Conlin Properties - 3710 Hubbell Avenue

Conlin Properties - 3710 Hubbell Avenue

APPROVAL of Part A) to find the requested rezoning is in conformance with the Des Moines' 2020 Community Character Plan future land use designations of Commercial: Auto-Oriented Small-Scale Strip Development and Medium Density Residential; Part B) to approve the proposed rezoning from "C-2" General Retail and Highway Oriented Commercial District and "R1-80" One-Family Residential District to "PUD" Planned Unit Development District; and Part C) to approve the proposed PUD Conceptual Plan for Hilltop Apartments, subject to the following revisions: (ZON2012-00172)

STAFF REPORT

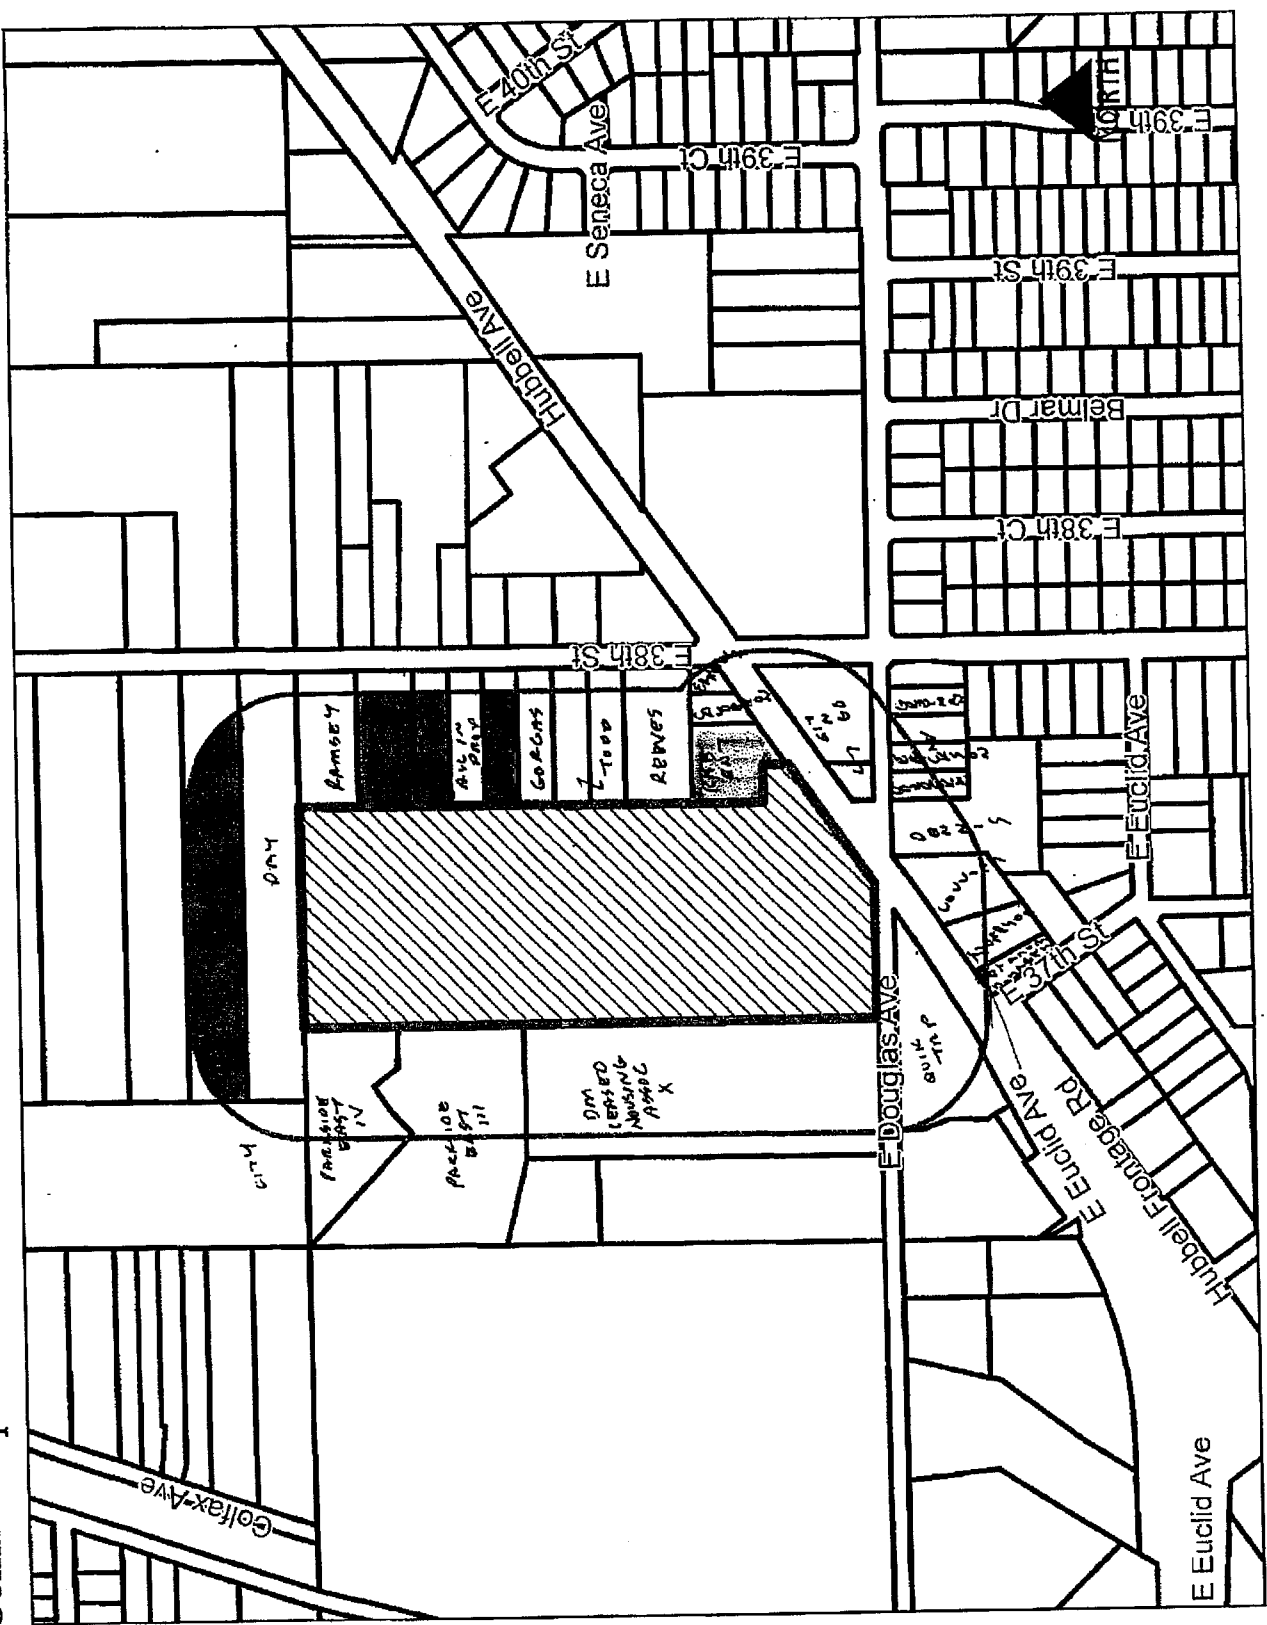
1. **Natural Site Features:** The site includes significant vegetation within the rear portion of the site and along the east fence line. The PUD Conceptual Plan does not identify size or species of trees within these areas but states that the future PUD Development Plan would identify trees and be in accordance with the Chapter 10, Article 42 of the City Code (Tree Preservation & Mitigation Ordinance).

4. **Landscaping & Buffering:** The PUD Conceptual Plan states that the development will generally be landscaped in accordance with the landscape requirements as applicable to the "R-3" District. In addition to these requirements, the PUD Conceptual Plan provides a buffer along the east and north site boundaries that includes a 6-foot tall

solid wood fence and 4 overstory trees and 8 evergreen trees per 100 lineal feet. In this instance, staff believes that given the topography in the area where some of the properties to the east are elevated above the site, it may be more appropriate to provide a mix of additional overstory and ornamental trees in place of the proposed evergreens. Therefore, staff recommends the notes regarding the buffer be revised to state the buffers along the north and east property lines will include a 20-foot wide buffer containing a 6-foot tall solid wood fence, at least 4 overstory trees, and a mix of at least 8 additional evergreen, ornamental, or overstory trees.

The PUD Conceptual Plan states that a traffic study shall be submitted for review before a Development Plan will be reviewed and that the Development Plan shall reflect that traffic study regarding items such as driveway locations and the need for turn lanes or traffic control devices. Staff recommends that this note be clarified to state that the traffic study will include trip generation and distribution estimates for the proposed development, including analysis of the impact on the surrounding street system. Since the traffic study has not yet been conducted and submitted to the City's Traffic & Transportation Division, the developer is aware that the layout on the PUD Conceptual Plan is preliminary only and may be required to be altered based on the findings of the necessary traffic study. If the Development Plan is significantly different than the PUD Conceptual Plan, the PUD Conceptual Plan may have to brought back to the Commission for an amendment.

The PUD Conceptual Plan provides 15 feet for future Hubbell Avenue right-of-way. It also indicates that sidewalks will be provided throughout the development and along Hubbell Avenue and East Douglas Avenue. (Note: The proposed 30-foot building setback line along Hubbell should be shifted 15 feet to accommodate the demonstrated 15 feet of future Hubbell Avenue right-of-way.)

The PUD must also include the following note: In accordance with IFC Section 508.5.1; where a portion of the facility or building hereafter constructed or moved into or within the jurisdiction is more than 400 feet from a hydrant on a fire apparatus access road, as measured by an approved route around the exterior of the facility or building, on-site fire hydrants and mains shall be provided (Exception: sprinklered buildings shall be no more than 600 feet from a hydrant).

The multiple-family residential buildings also include balconies constructed of treated wood, painted wood, or painted metal. Staff recommends that this note be revised to require all balconies to be constructed of metal materials rather than wood materials.

The submitted PUD Conceptual Plan only includes elevations of the front and side facades of the multiple-family structures. Staff recommends that the PUD Conceptual Plan include the elevations for all facades of the structures to the satisfaction of the Planning Director.

The PUD Conceptual Plan demonstrates that the proposed one-family and two-family structures would be sided with a brick wainscot on all facades, with the balance sided with 4-inch exposure horizontal overlap siding and shake-pattern siding. The submitted PUD Conceptual Plan only includes a typical elevation of a one-family dwelling. Staff recommends the PUD Conceptual Plan also include a typical elevation of a two-family dwelling to the satisfaction of the Planning Director.

The PUD Conceptual Plan must include conceptual elevations of the proposed accessory structures (clubhouse, fitness center, computer center, etc). The elevations should include brick and siding materials compatible with the primary structures.

- 39 30
1. The notes regarding the buffer be revised to state the buffers along the north and east property lines will include a 20-foot wide buffer containing a 6-foot tall solid wood fence, at least 4 overstory trees, and a mix of at least 8 additional evergreen, ornamental, or overstory trees.

2. The note regarding the required traffic study shall be clarified to state that the traffic study will include trip generation and distribution estimates for the proposed development, including analysis of the impact on the surrounding street system. The layout of the PUD Conceptual Plan is preliminary only and, based on the findings of the traffic study, driveway locations may be required to be altered, and turn lanes and/or traffic signals may be required. If the Development Plan is significantly different than the PUD Conceptual Plan, the PUD Conceptual Plan may have to amended.

3. The 30-foot building setback line along Hubbell shall be shifted 15 feet to accommodate the demonstrated 15 feet of future Hubbell Avenue right-of-way.

4. Provision of the following note: In accordance with IFC Section 508.5.1; where a portion of the facility or building hereafter constructed or moved into or within the jurisdiction is more than 400 feet from a hydrant on a fire apparatus access road, as measured by an approved route around the exterior of the facility or building, on-site fire hydrants and mains shall be provided (Exception: R-3, U & sprinklered buildings shall be no more than 600 feet from a hydrant).

5. The PUD Conceptual Plan shall indicate that vinyl shall not be a permitted material for the proposed horizontal overlap siding.
 6. The PUD Conceptual Plan shall indicate that all balconies on the multiple-family residential structures shall be constructed with predominantly metal materials.

7. The PUD Conceptual Plan shall include the elevations for all facades of the multiple-family residential structures to the satisfaction of the Planning Director.

8. The PUD Conceptual Plan shall include a typical elevation of a two-family dwelling to the satisfaction of the Planning Director. The elevations shall include brick and siding materials compatible with the proposed elevation for the one-family dwellings.

9. The PUD Conceptual Plan shall include conceptual elevations of the proposed accessory structures (clubhouse, fitness center, computer center, etc) to the satisfaction of the Planning Director. The elevations shall include brick and siding materials compatible with the primary structures.
